#### **Arlington Conservation Commission**

**Date:** Thursday, February 17, 2022

#### **Notice of Intent: Hurd Field**

**Reference: Response to NOI Comments**

- 1) Revised drawing: "Materials Plan", dated 2/9/2022
- 2) Revised drawing: "Planting Plan", dated 2/9/2022
- 3) Revised Rendered Site Plan
- 4) Operations and Maintenance Plan

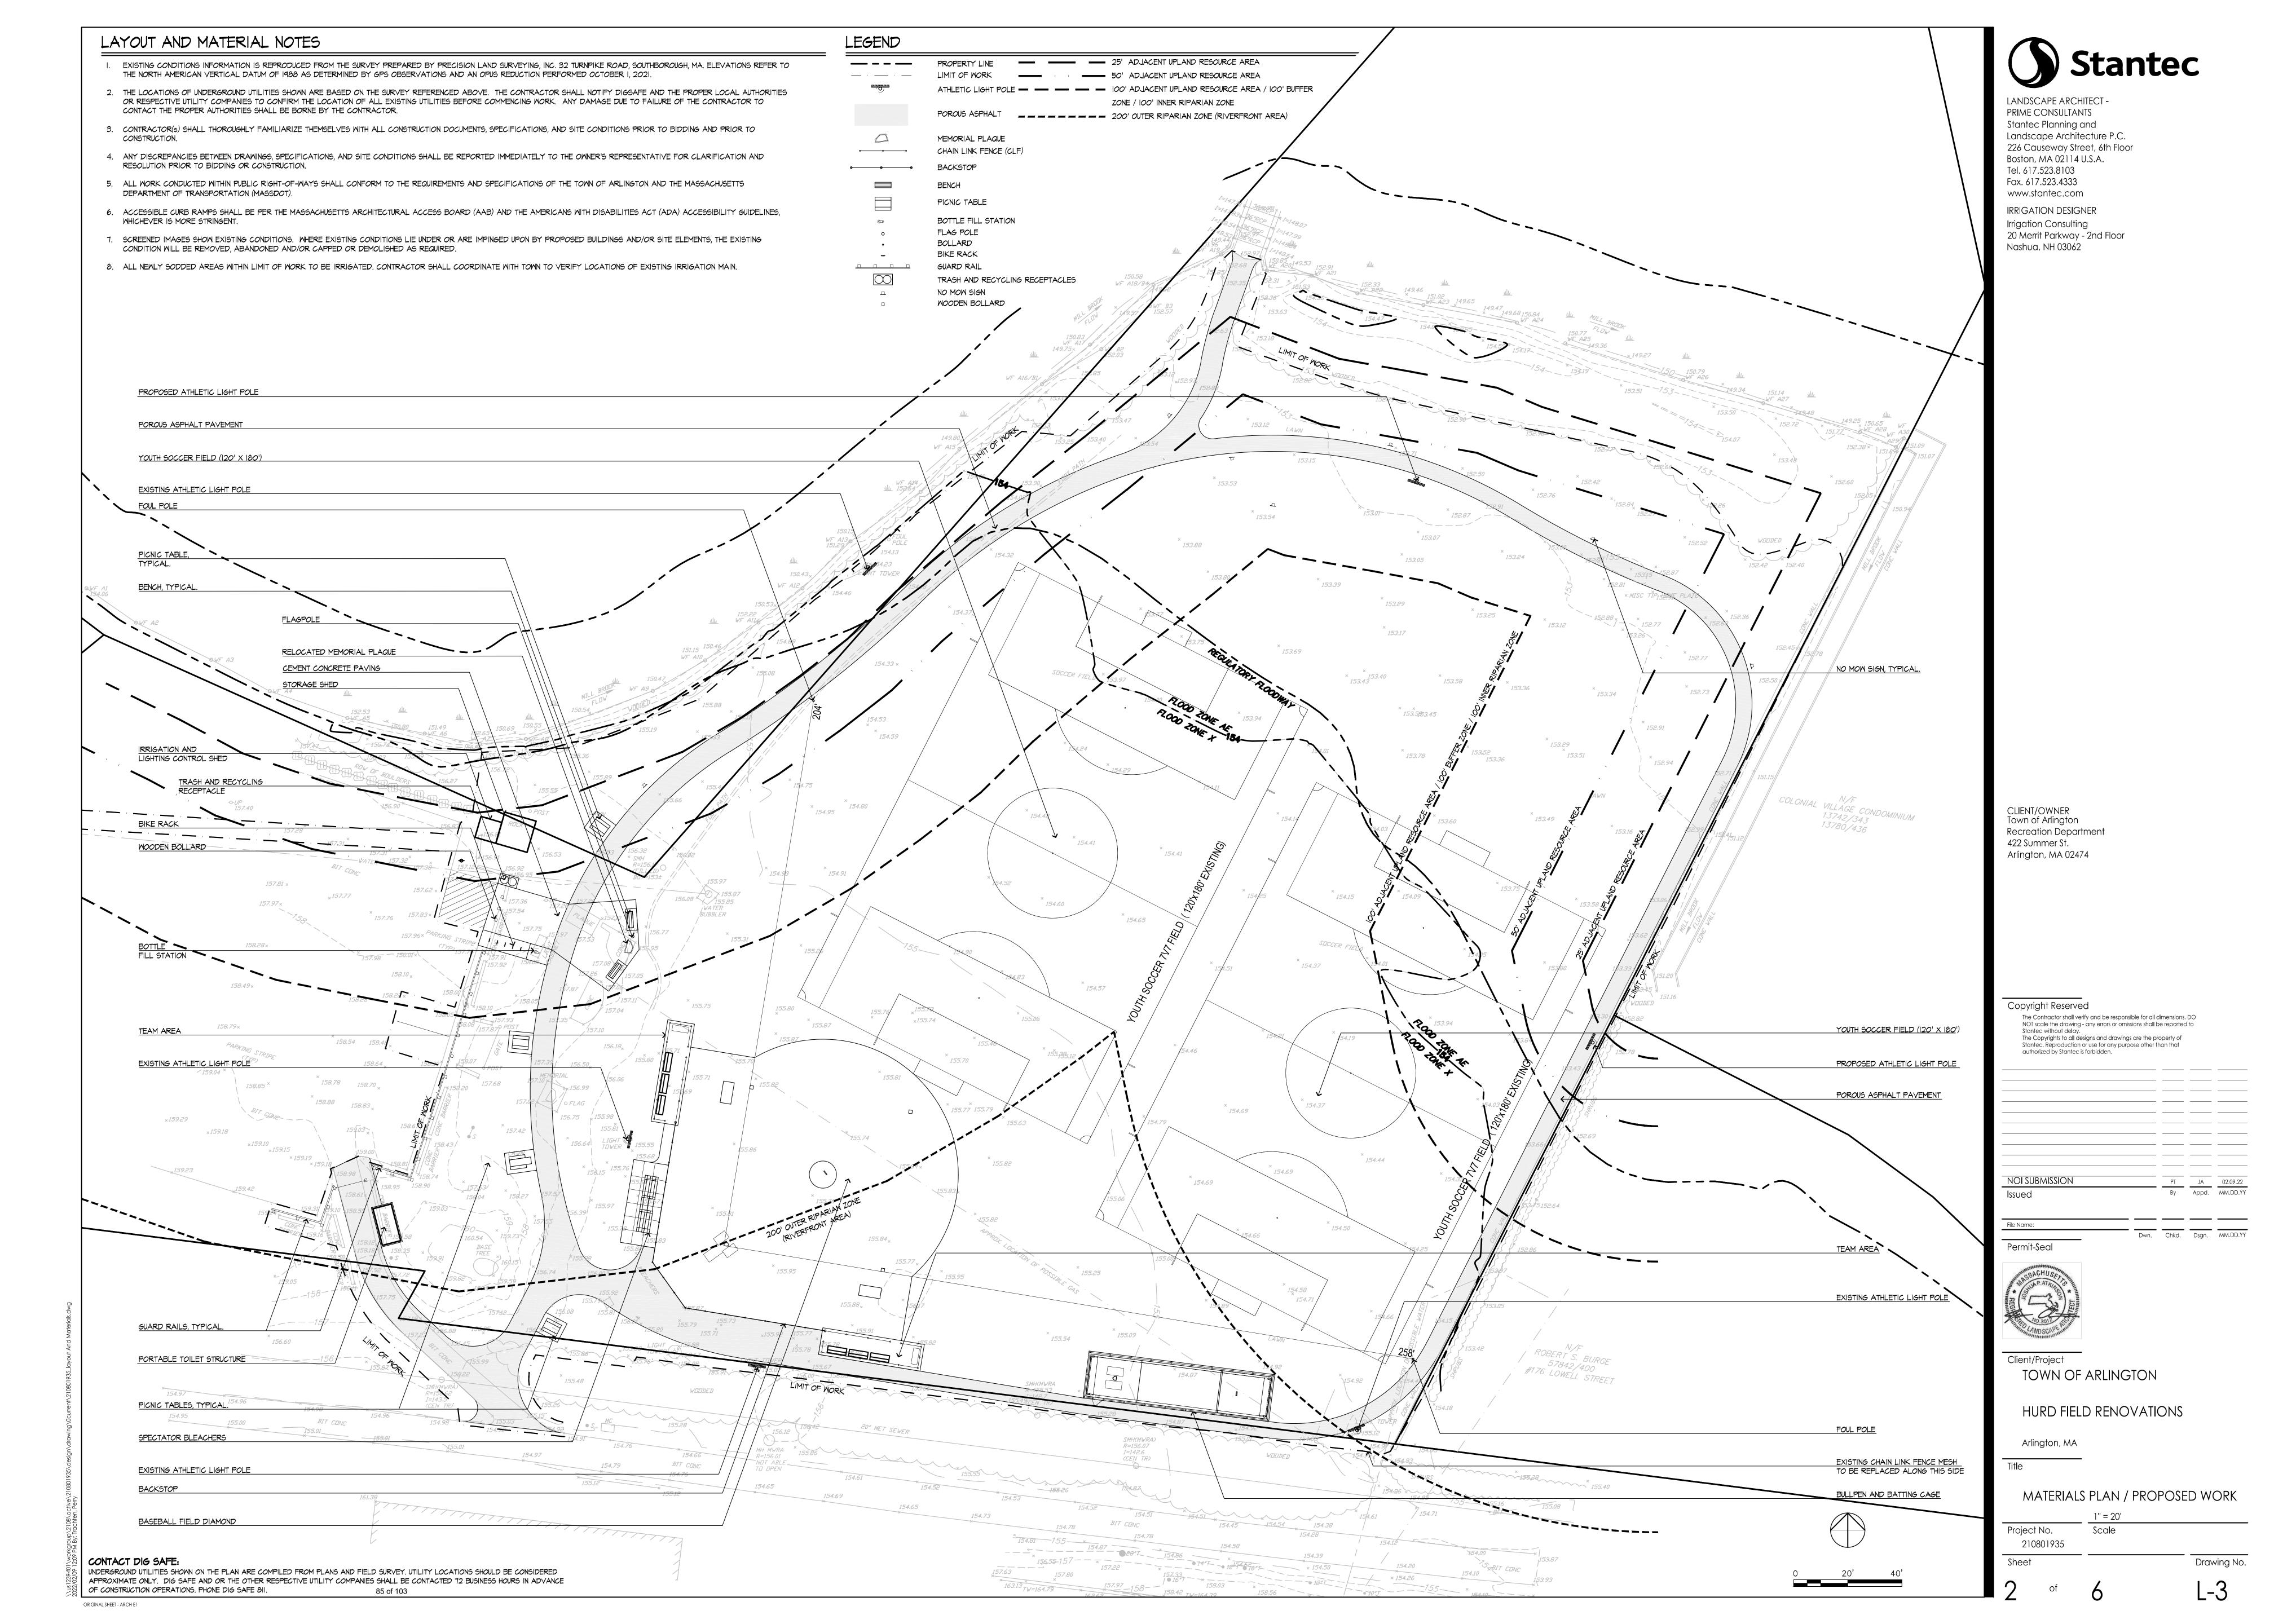
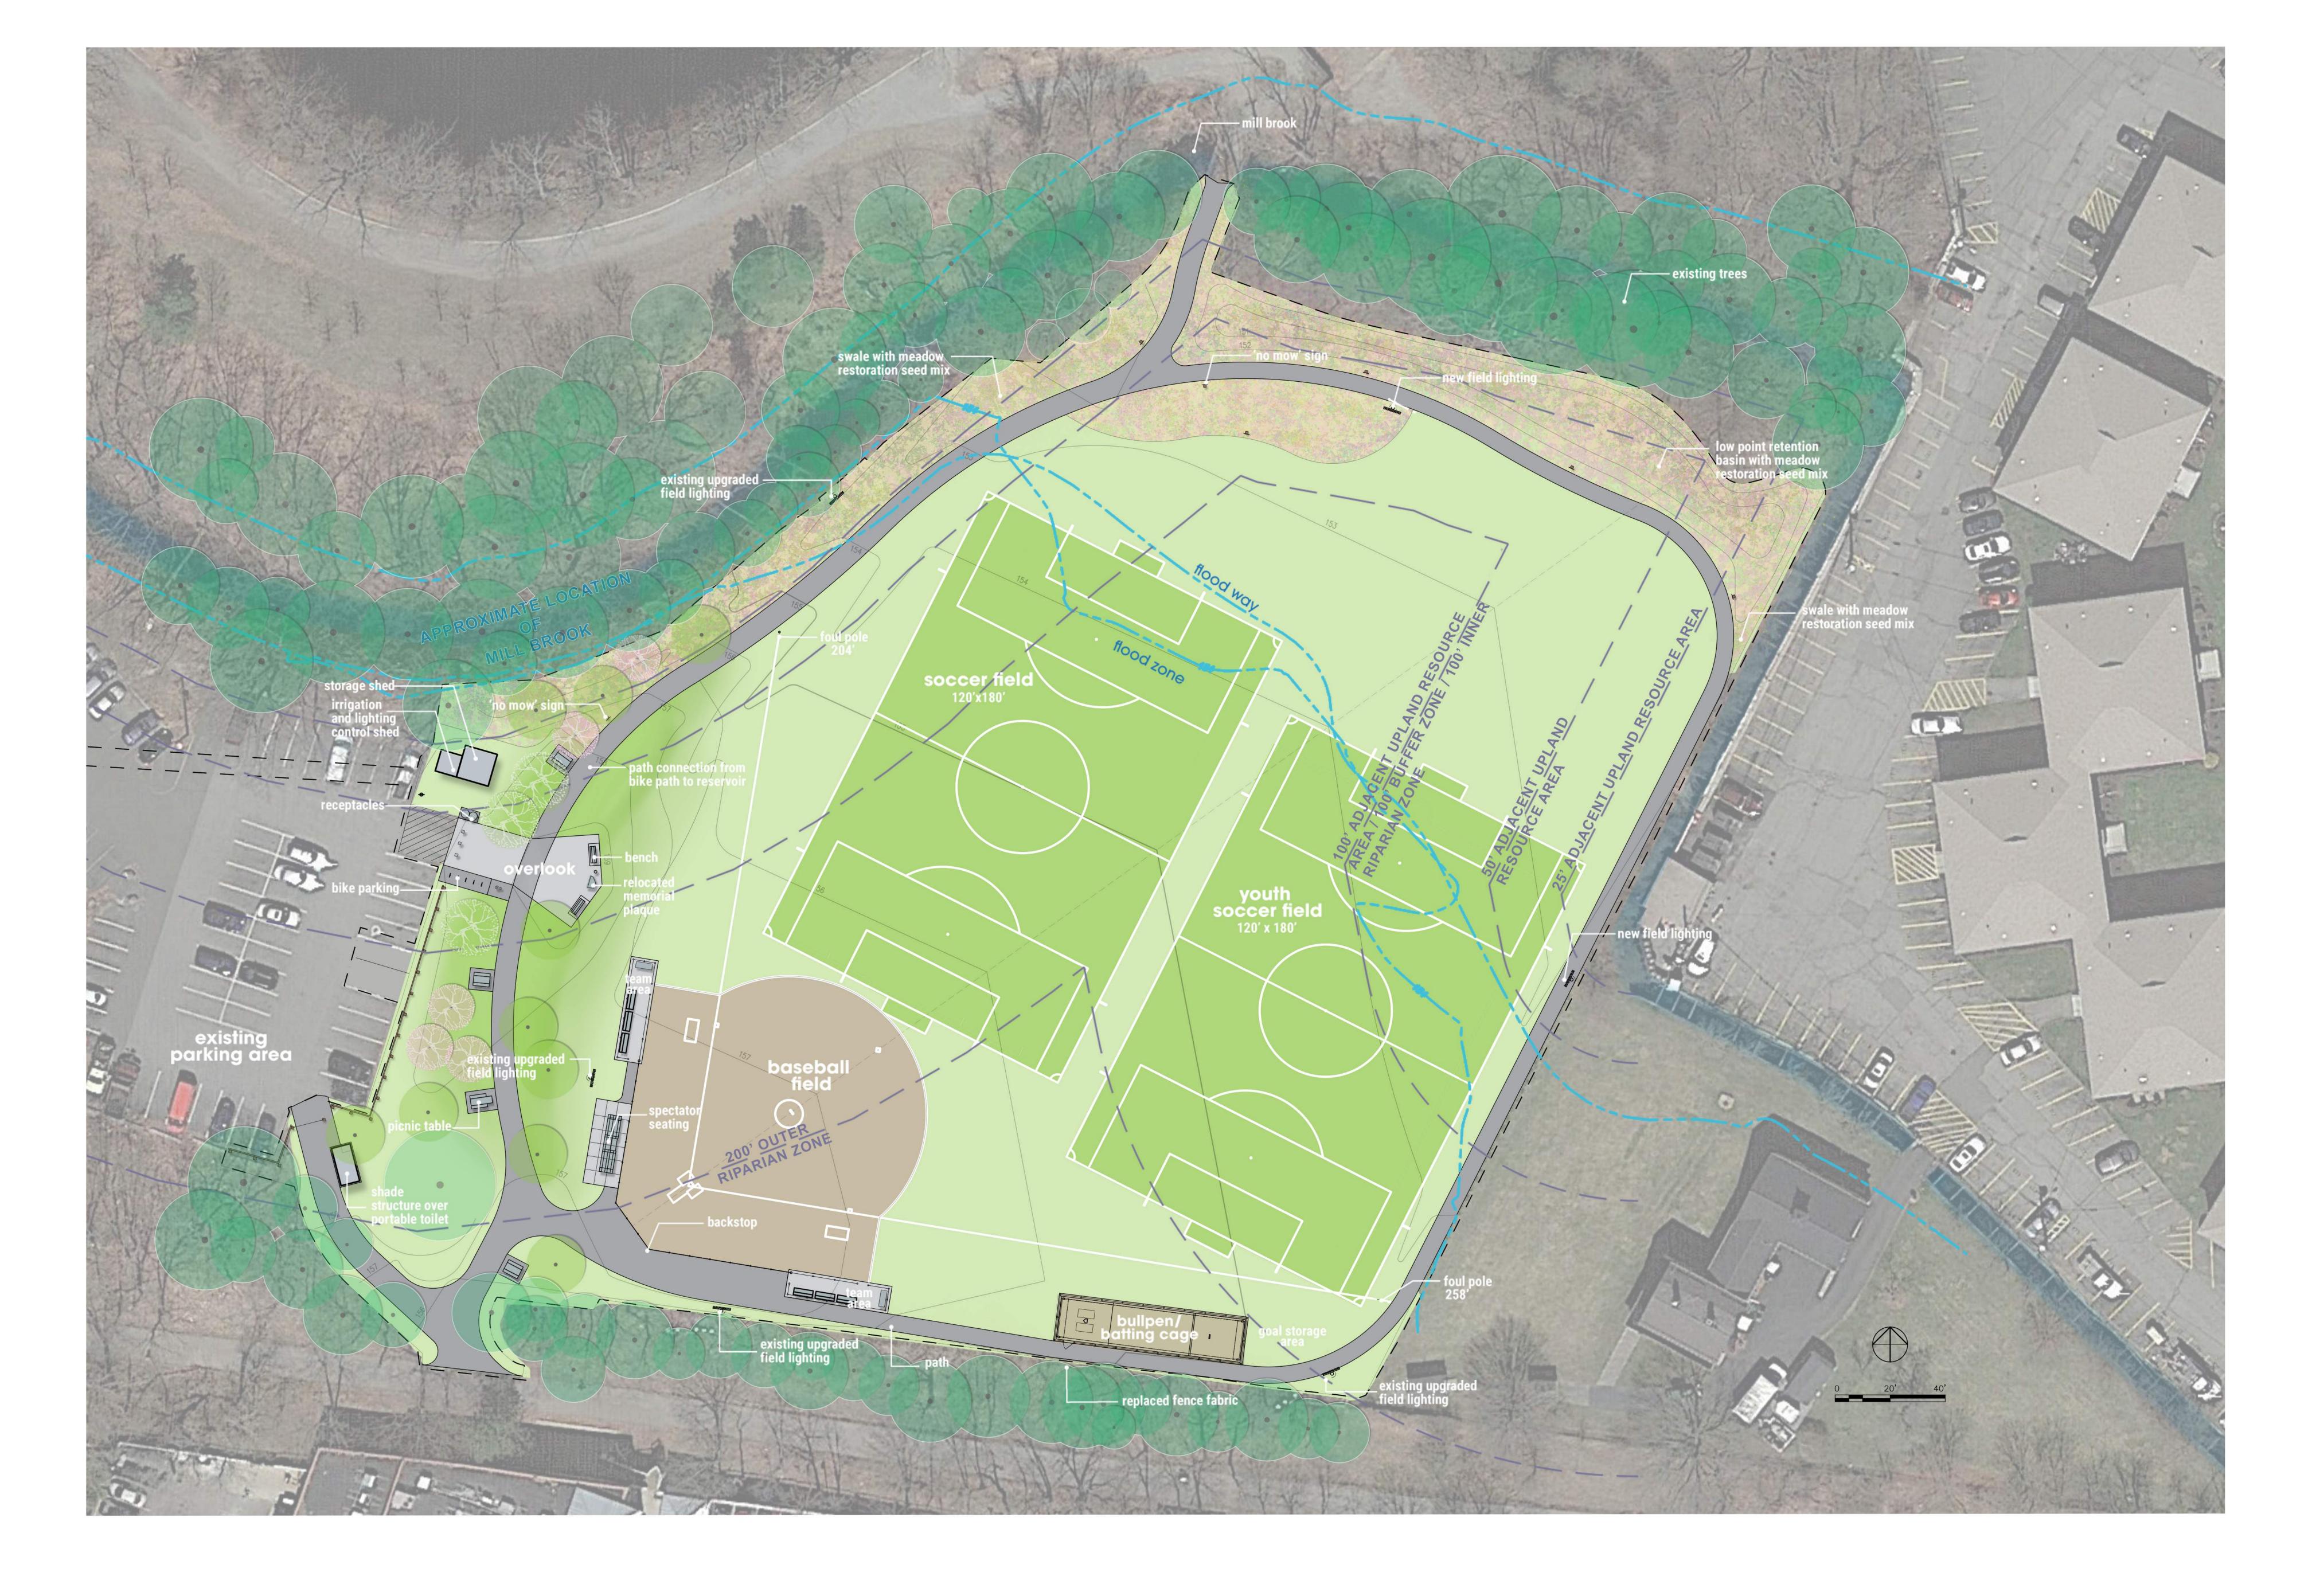
The path was re-evaluated and, after comments from the Conservation Commission, the path from the bike path to the Reservoir meanders. At the request of Recreation Commission, the loop path was brought back into the design and has minimized area inside the 25' AURA as much as possible by reducing the practice field in the north, yet still allowing for the needed field rotation for the fields and ADA accessibility. Please see attached rendered site plan.

With the re-introduction of the loop path, additional meadow restoration seed mix has been added in the northeastern and northwestern areas of the site, however trees will not be planted into the floodway. The mitigation of overall native meadow restoration seed mix and tree planting has offset the degraded areas as shown in the below table. In addition,

4. Provide a tree substitution for the Eastern Redbud.

fence removal along the northwestern side would require tree removal and invasive species removal. This is not part of the scope of this project at this current time. Please see attached rendered site plan and Planting Plan.

The Eastern Redbud is now substituted with Cornus Florida, Flowering Dogwood. Please see attached Planting Plan.
